# AMENDMENT OF SOLICITATION/MODIFICATION OF CONTRACT

2

98946.3

The purpose of Amendment 2 is to:

8. **REFERENCE:** Specification section 23 73 13.00 40 Paragraph 2.7

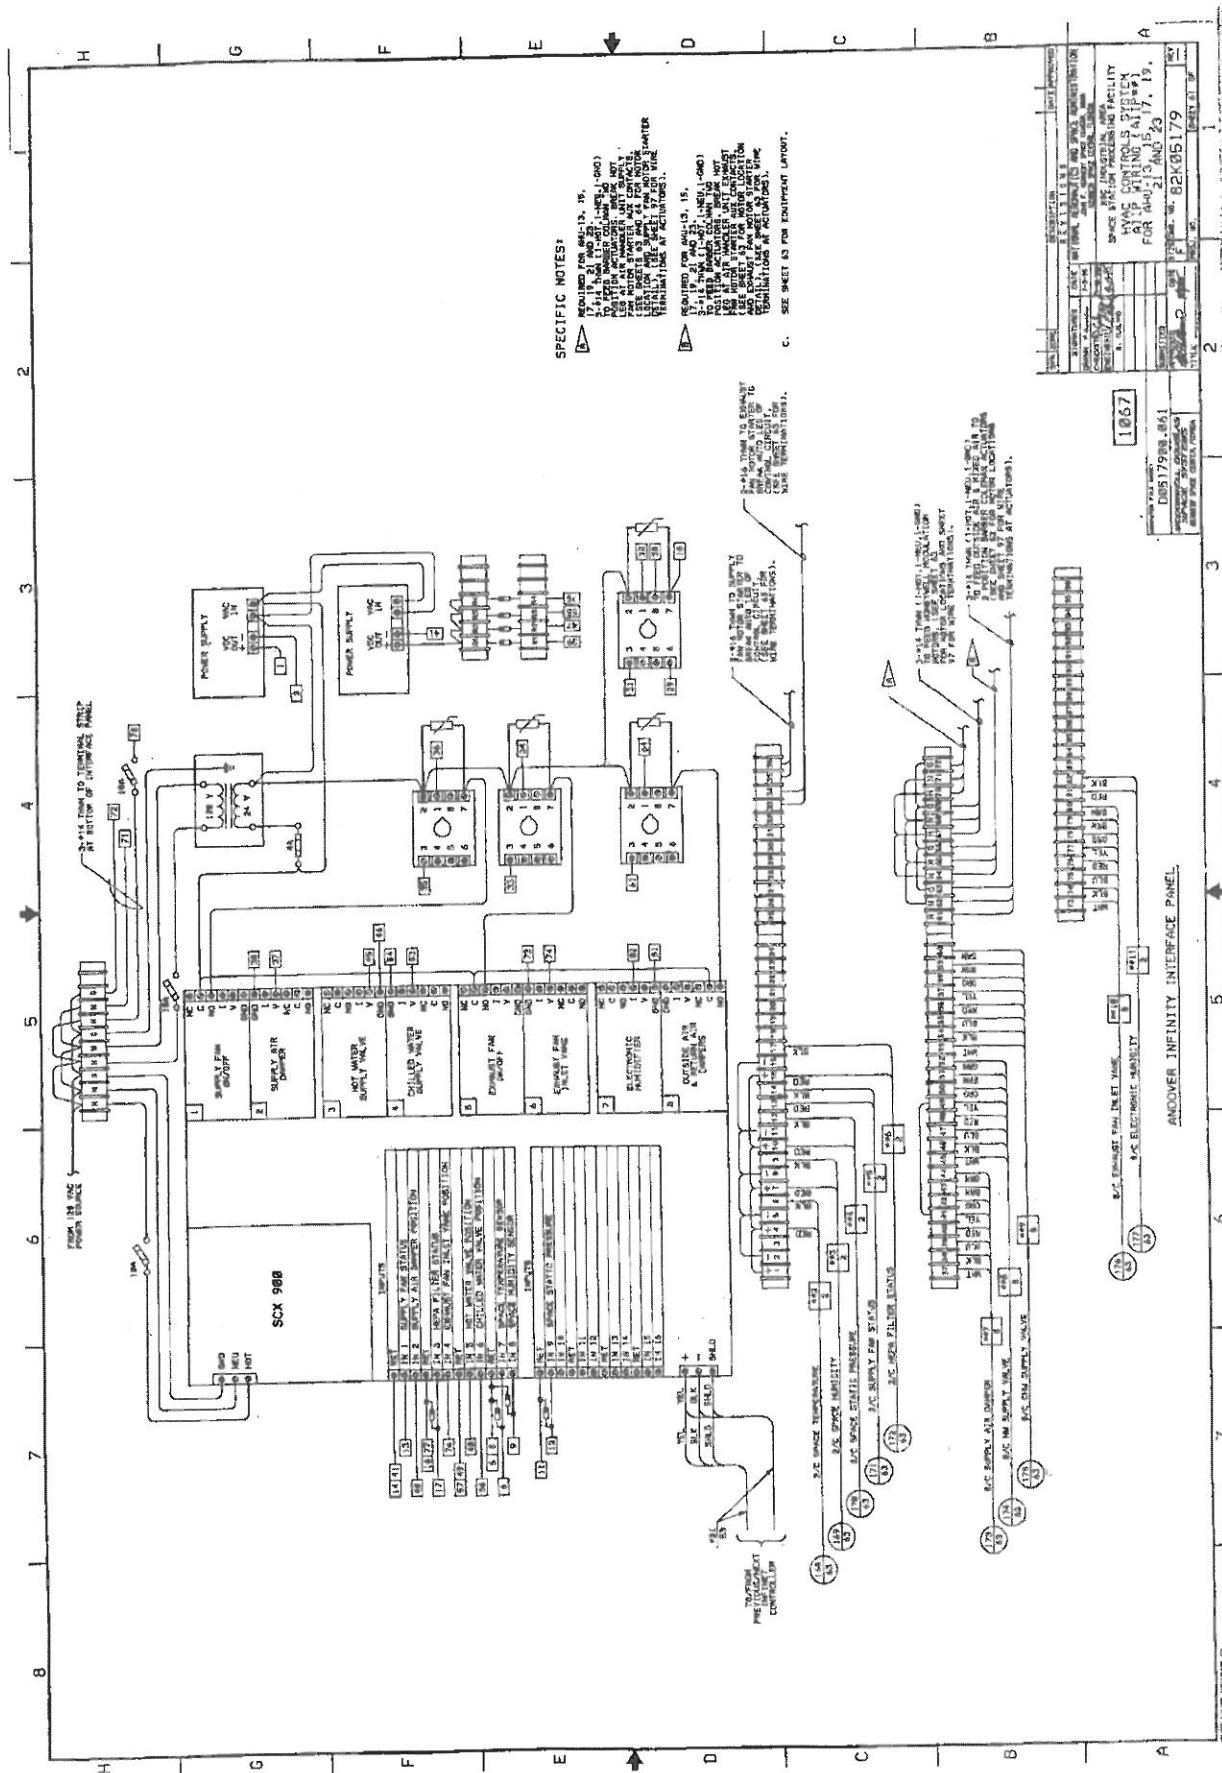
**QUESTION:** This section states that “Water coils shall have the following construction: 5/8” diameter min., .0020” wall copper tube, .010” aluminum fins.....” The previous two phases of this project have required “Copper Fins” and .025” copper tube thickness on all coils (Temtrol AHU’s on both of the two phases). Please advise what coil construction should be provided.

**RESPONSE:** Include aluminum fins in the base price.
